T-ROC2 Layout modifications

Jorge Casaus, Gustavo Martínez, Carlos Díaz, Jesús Marín

Previous errors: √ Digital

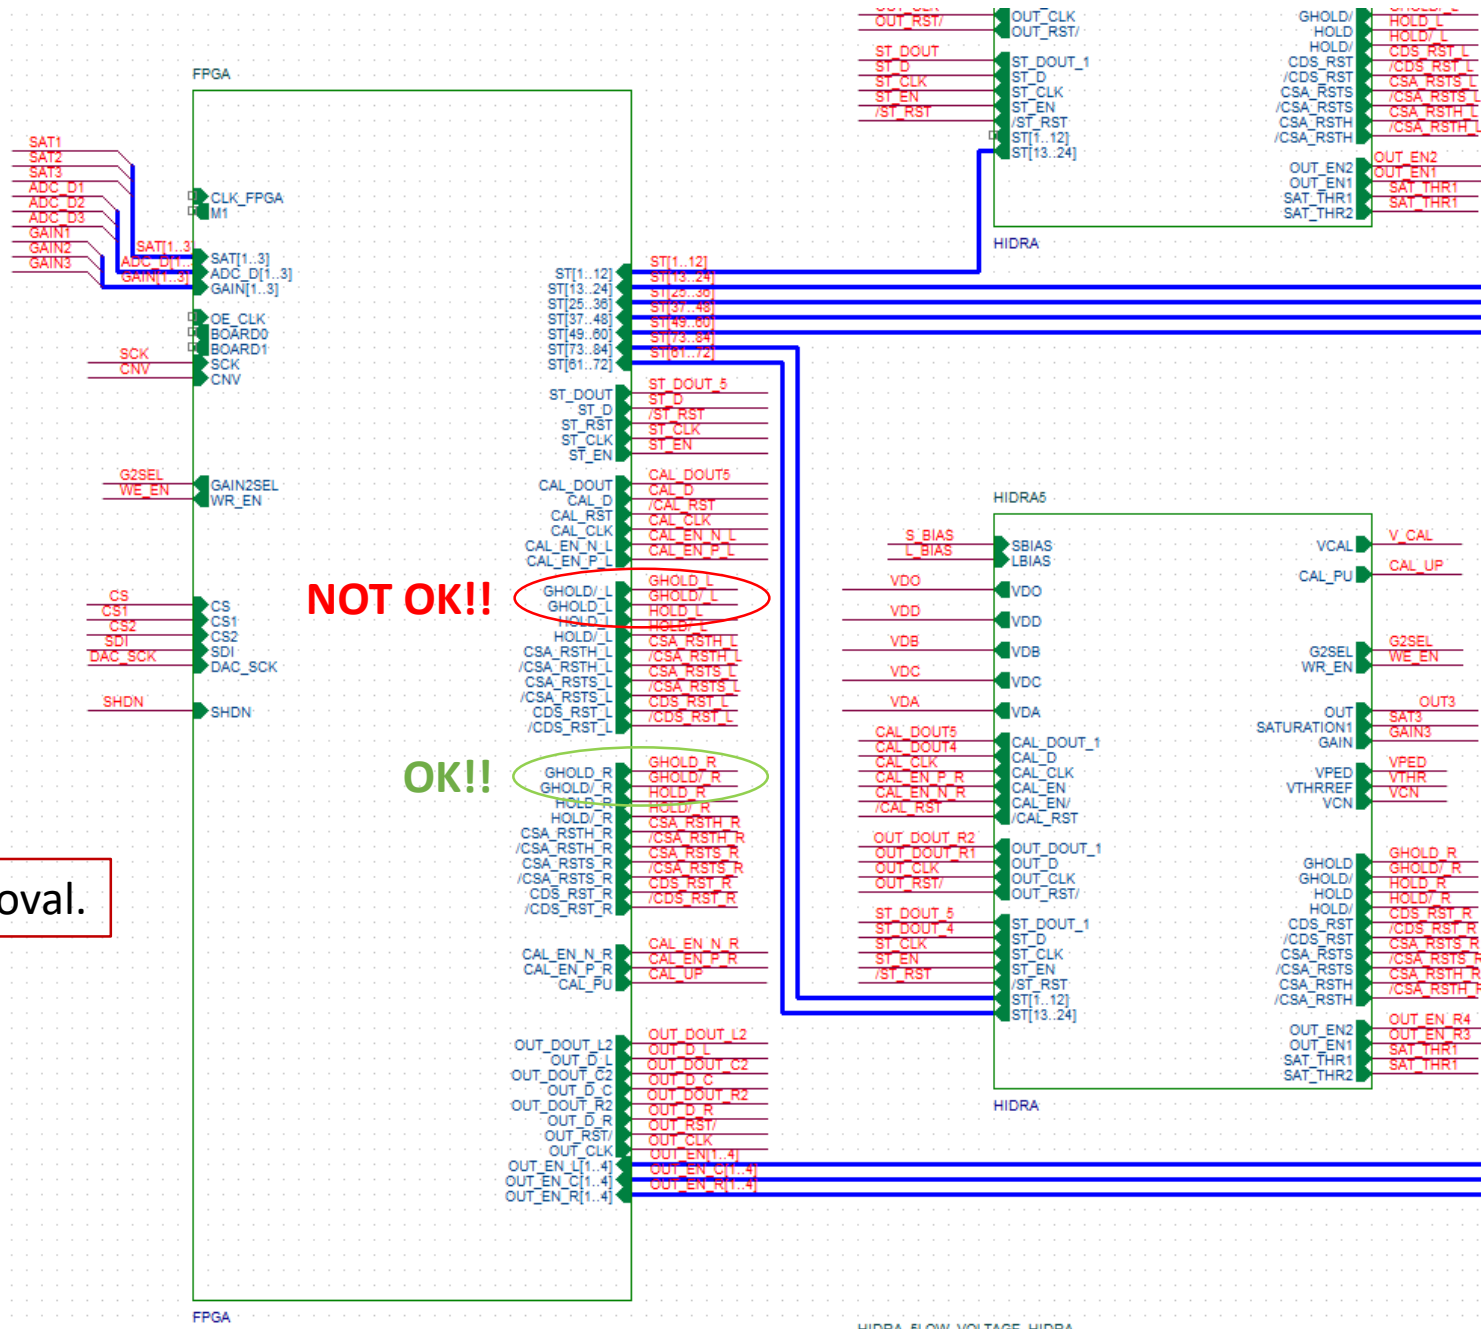
Signal swap removal.

Mechanical: √ Shield

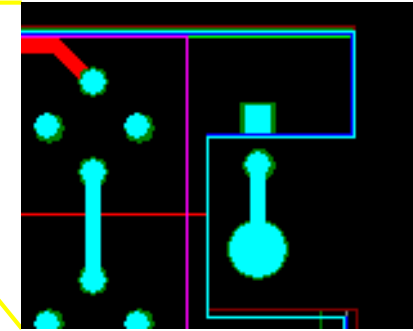
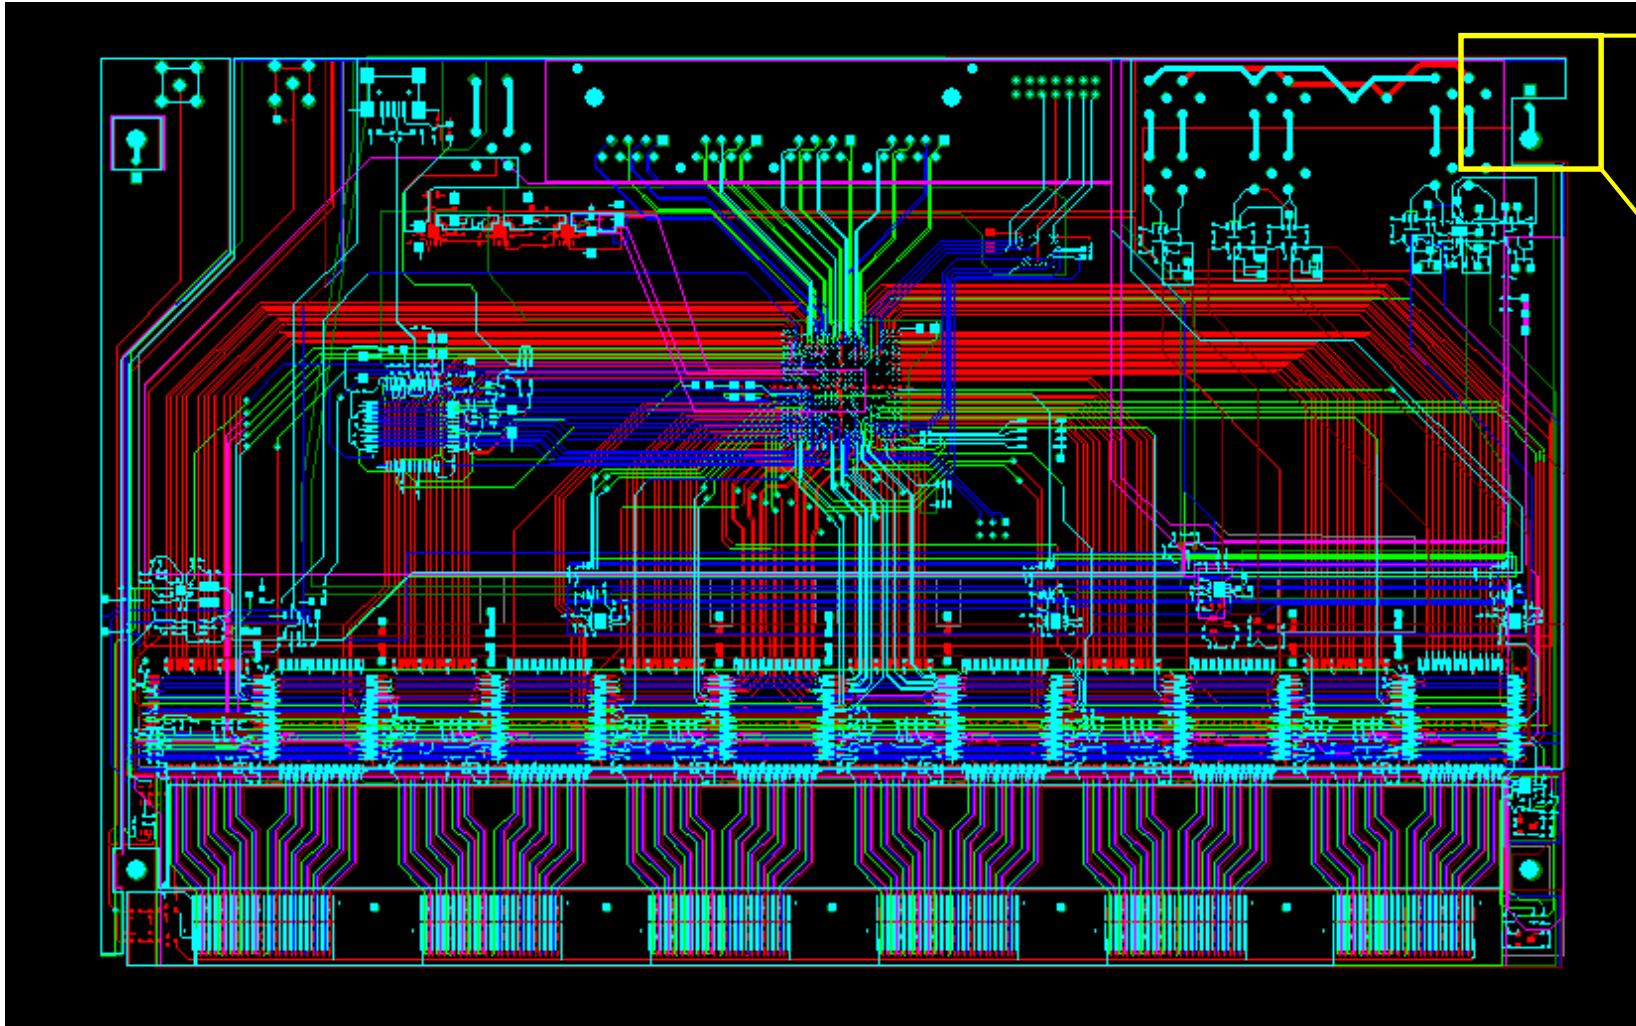
Screw holes lay-out changed to avoid external connections and washer isolation.

Mechanical: √ Screws interferences

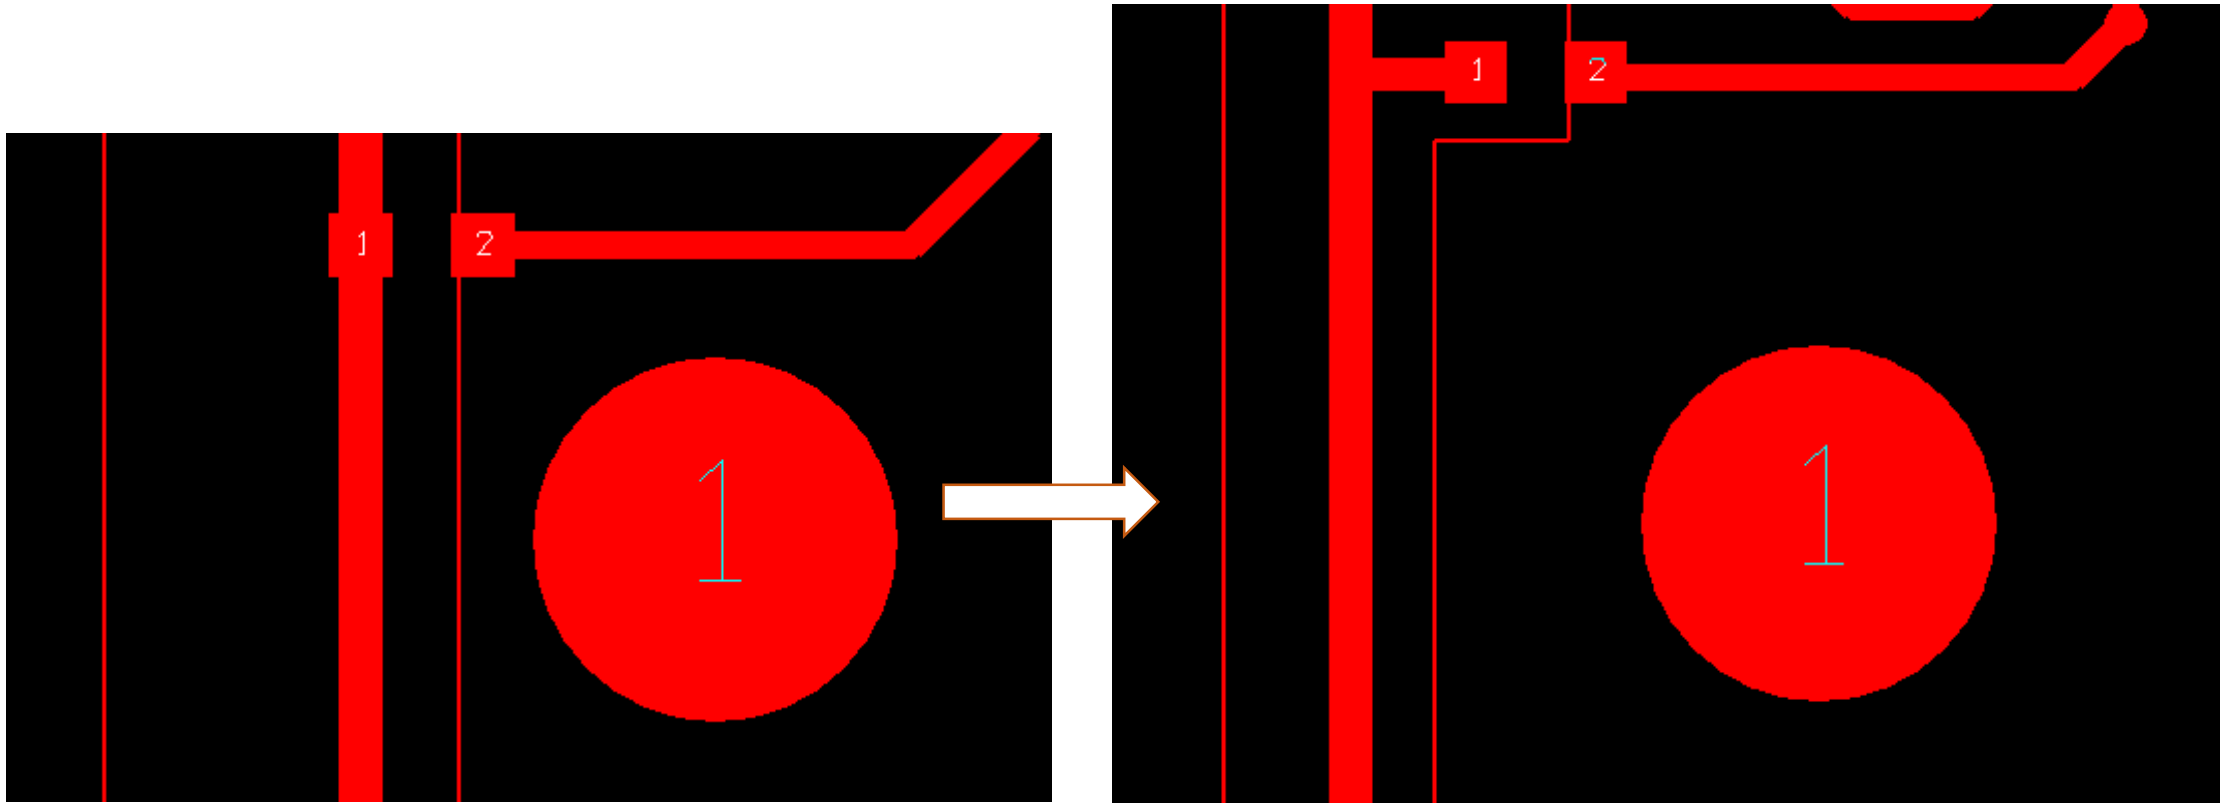
Some components moved to avoid assembly interferences.

Mechanical: √ Assembly

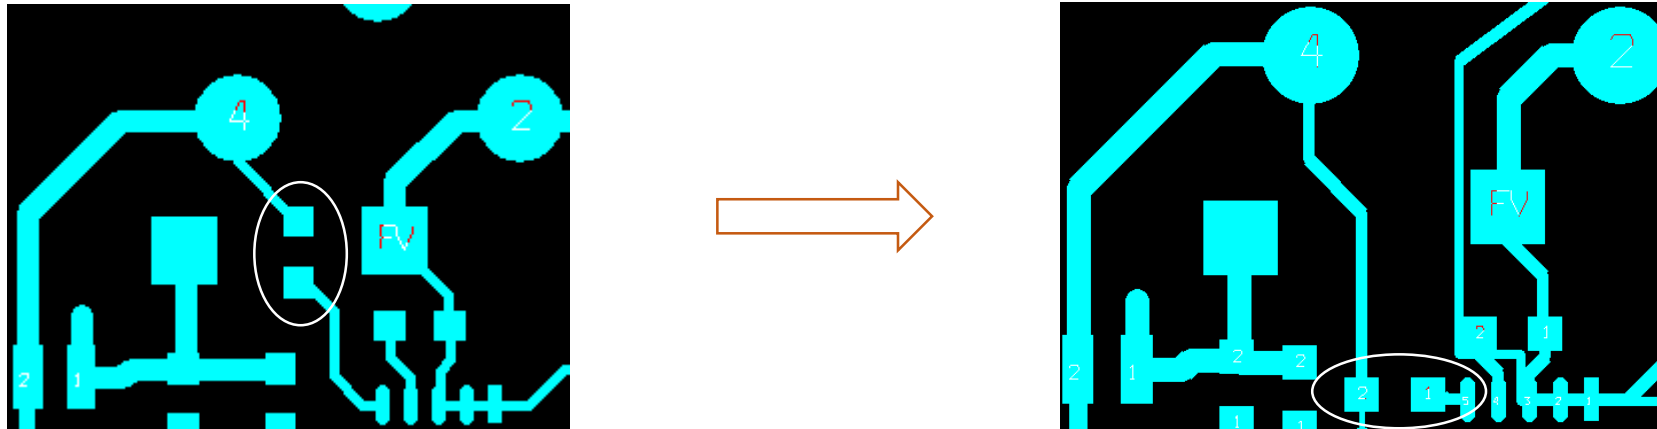
Some components moved to avoid assembly interferences.

BIAS reference.

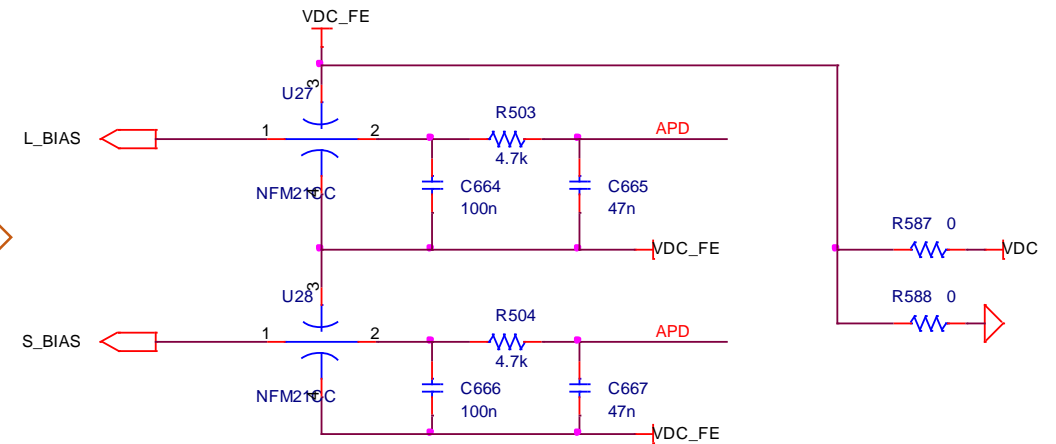
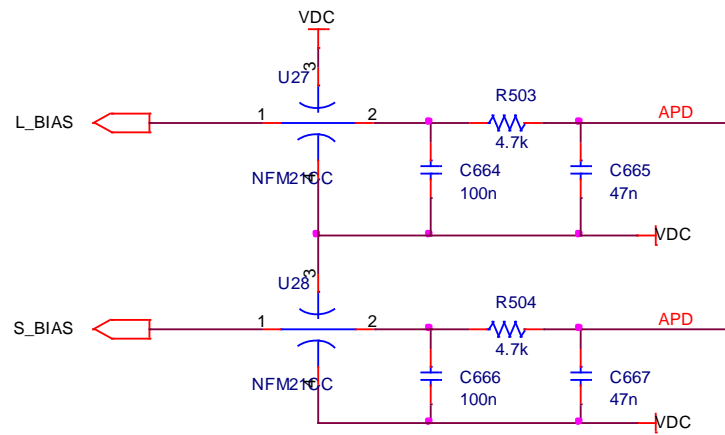
✓ PD BIAS reference \equiv 3,3 Volts

✓ PD BIAS reference

3,3 Volts

GND

Increased flexibility on bias circuitry.

ADC Supply

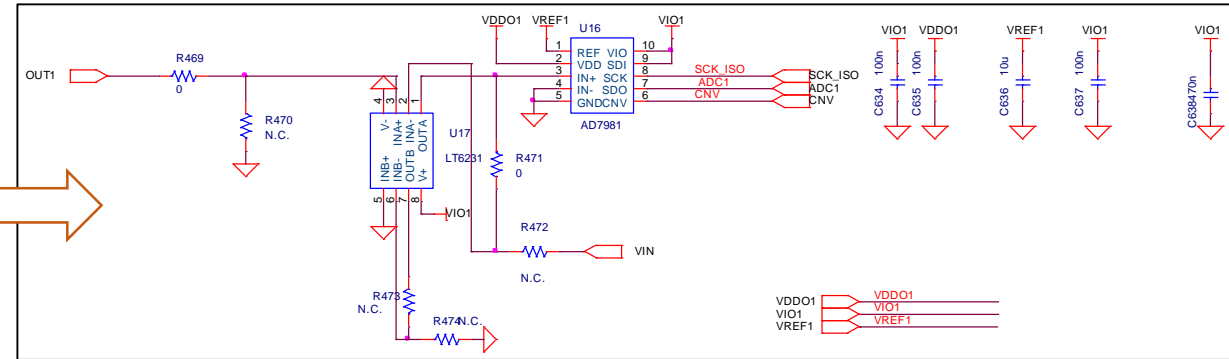
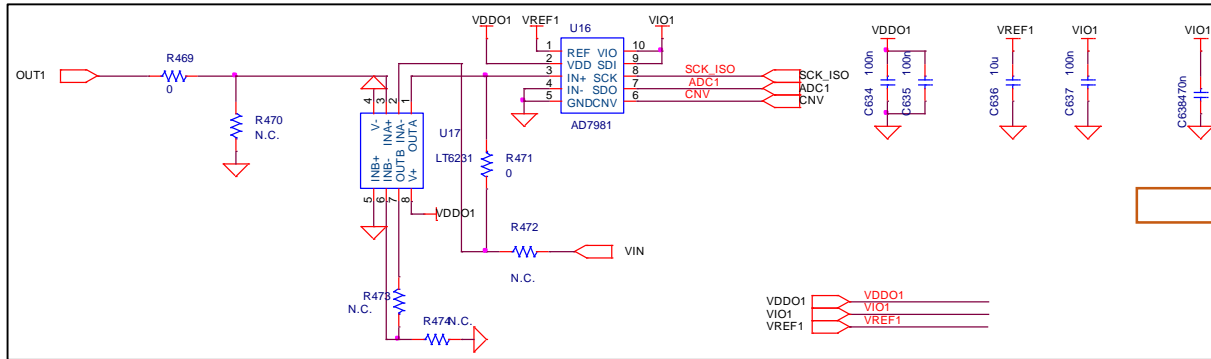
- ✓ VIO1 ≡ 2,5 Volts
- ✓ VREF1 ≡ 2,5 Volts
- ✓ VDDO1 ≡ 2,5 Volts

- ✓ VIO1 ≡ 3,3 Volts
- ✓ VREF1 ≡ 3,0 Volts
- ✓ VDDO1 ≡ 2,5 Volts

ADC REF and INPUT BUFFER supply increased to improve linearity and avoid saturation.
